PIC16C74A Rev. A Silicon Errata Sheet

The PIC16C74A (Rev. A) parts you have received conform functionally to the Device Data Sheet (DS30390E), except for the anomalies described below.

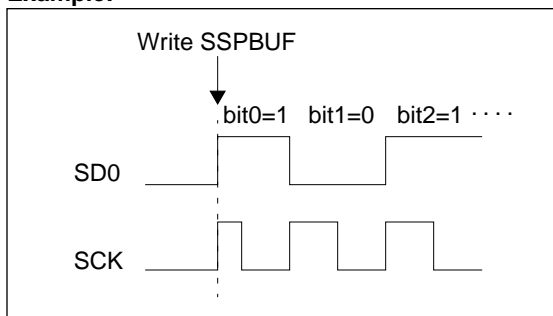
3. Module: CCP (Compare Mode)

The special event trigger of the Compare mode may not occur if both of the following conditions exist:

- An instruction one cycle (T_{CY}) prior to a Timer1/Compare register match has literal data equal to the address of a CCP register being used.⁽¹⁾
- An instruction in the same cycle as a Timer1/Compare register match has an MSb of '0'.

The interrupt for the compare event will still be generated, but no special event trigger will occur.

Use the interrupt service routine instead of using the special event trigger to reset Timer1 (and start an A/D conversion, if applicable).

FIGURE 1: WRITES TO TIMER1 (EXTERNAL CLOCK / OSCILLATOR MODE)

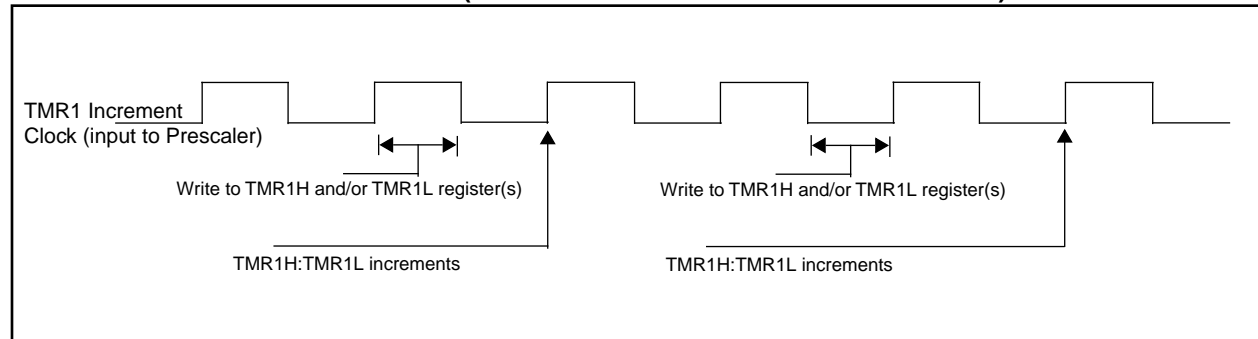
- a) The operation of Timer1 needs some clarification when the timer registers are written when the TMR1ON bit is set.

The internal clock signal that is the input to the TMR1 prescaler affects the incrementing of Timer1 (TMR1H:TMR1L registers and the Timer1 prescaler). When the Timer1 registers are NOT written, the Timer1 will increment on the rising edge of the TMR1 increment clock.

When the TMR1H and/or TMR1L registers are written while this clock is high, TMR1 will increment on the next rising edge of this clock.

When the TMR1H and/or TMR1L registers are written while this clock is low, TMR1 will not increment on the next rising edge of this clock, but must first have a falling clock and the rising clock for TMR1 to increment.

Figure 1 shows the two cases of writes to the TMR1H and/or TMR1L registers. Due to the V_{IH} and V_{IL} thresholds on the oscillator/clock pins, external Timer1 oscillator components, and external clock frequency, the Timer1 increment clock may not be of a 50% duty cycle.

The TMR1 increment clock is out of phase of the T1OSO/T1CKI pin by a small propagation delay.
